SUBDIVISION REVIEW SHEET**CASE NO.:** C8-2018-0043.2A**COMMISSION DATE:** April 6, 2021**SUBDIVISION NAME:** Parkside Section 1 at Wildhorse Ranch**ADDRESS:** 9936-1/2 Lindell Lane**APPLICANT:** Forestar Group**AGENT:** BGE, Inc. (Pablo Martinez)**ZONING:** PUD**NEIGHBORHOOD PLAN:** N/A**AREA:** 37.39 acres**LOTS:** 145**COUNTY:** Travis**DISTRICT:** 1**WATERSHED:** Decker and Gilleland Creeks**JURISDICTION:** Full Purpose**SIDEWALKS:** Sidewalks will be constructed along the subdivision side of Lindell Lane and along both sides of all proposed, internal streets.**VARIANCES:** None**DEPARTMENT COMMENTS:**

FINAL PLAT PARKSIDE SECTION 1 AT WILDHORSE RANCH

CITY OF AUSTIN –DEVELOPMENT SERVICES DEPARTMENT SUBDIVISION APPLICATION – MASTER COMMENT REPORT

CASE NUMBER: C8-2018-0043.2A
REVISION #: 00
CASE MANAGER: Jennifer Bennett-Reumuth
UPDATE: U1
PHONE #: 512-974-9002

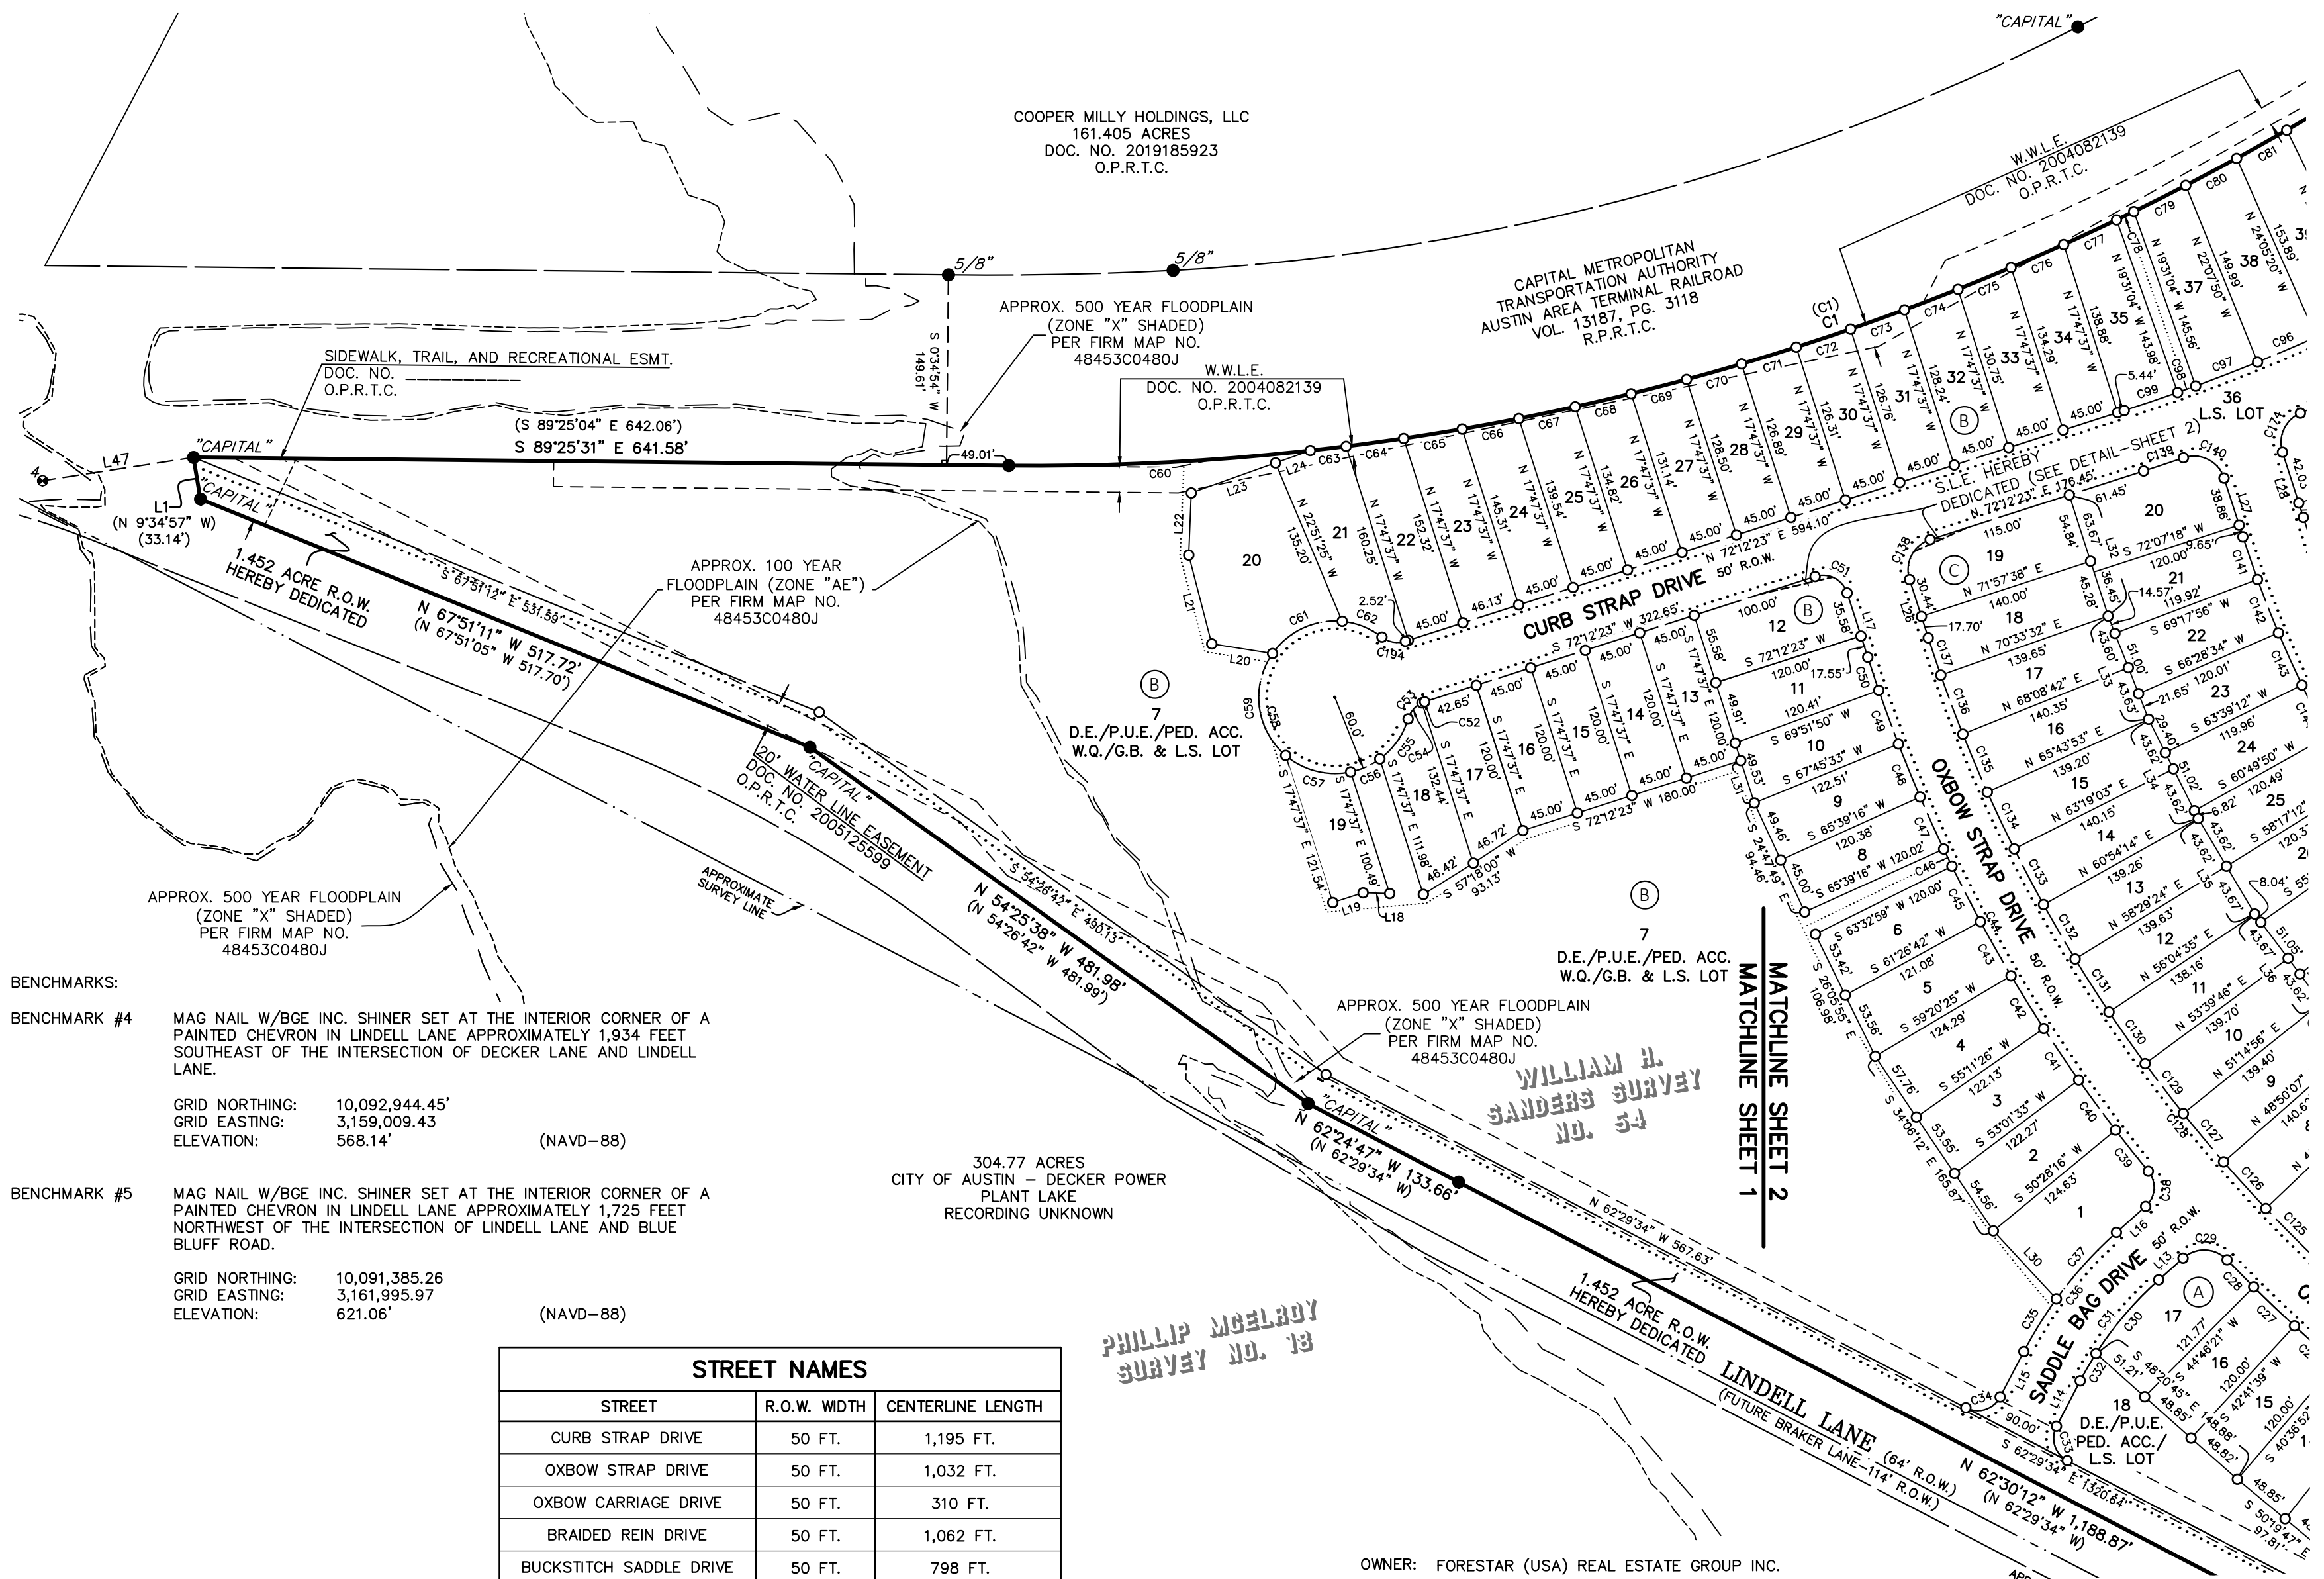
SR 1. Add the Case # C8-2018-0043.02A in the bottom right hand corner of each sheet. 25-1-83

SR 2. One concrete monument is required to be placed at or near a major property corner, if one is not located and shown within 1,300 feet on previously recorded property. (LDC § 25-4-131)

SR 3. Plat notes. These notes can be on the construction plans, but not the plat. 25-1-83

- Delete notes 3 and 11 that reference utility providers
- Delete note 6 that refers to site development regulations.
- Delete note 12 that refers to front setbacks and facades.
- Delete note 18 that refers to street signs. This can be on the construction plans.
- Delete note 22 that refers to an administrative variance.
- Delete note 28 that refers to clustered driveways.
- Delete note 34 that refers to the concrete path.

SR 4. Add the following plat note and list all the applicable lots and blocks (open space, drainage, water quality, etc) 25-1-83; 25-1-601:

SR 5. Revise the Land Use Commission approval block as follows. 25-4-57

WB1.Update0. This project area includes two wetland CEFs (see Property Profile) that are not shown to be protected on this Plat. These two wetlands have been identified for preservation, and shall be shown on the Plat in order to provide clear communication to guide future development plans. To clear this comment, please clearly show and label "Wetland CEF" the two wetland CEFs near the western corner of the project, and include "CEF Setback" to the list of approve uses for the lot B7. 25-8-281, 25-8-282 and ECM 1.10

WB2.Udpate0. The two wetland CEFs located near the western corner of the project shall be preserved/protected with CEF setbacks. If applicant proposes 1:1 in-kind mitigation that is protective of the CEF and the character/function of the CEF setback, then administratively modified CEF setbacks could be approved. To clear this comment, please include a note on the cover that indicates that "Wetland Critical Environmental Features (CEFs) within this project shall be protected with CEF setbacks. CEF setbacks that are less than the Standard Setback may be administratively modified/reduced in conjunction with 1:1 in-kind mitigation pursuant to code and criteria." 25-8-281, 25-8-282 and ECM 1.10
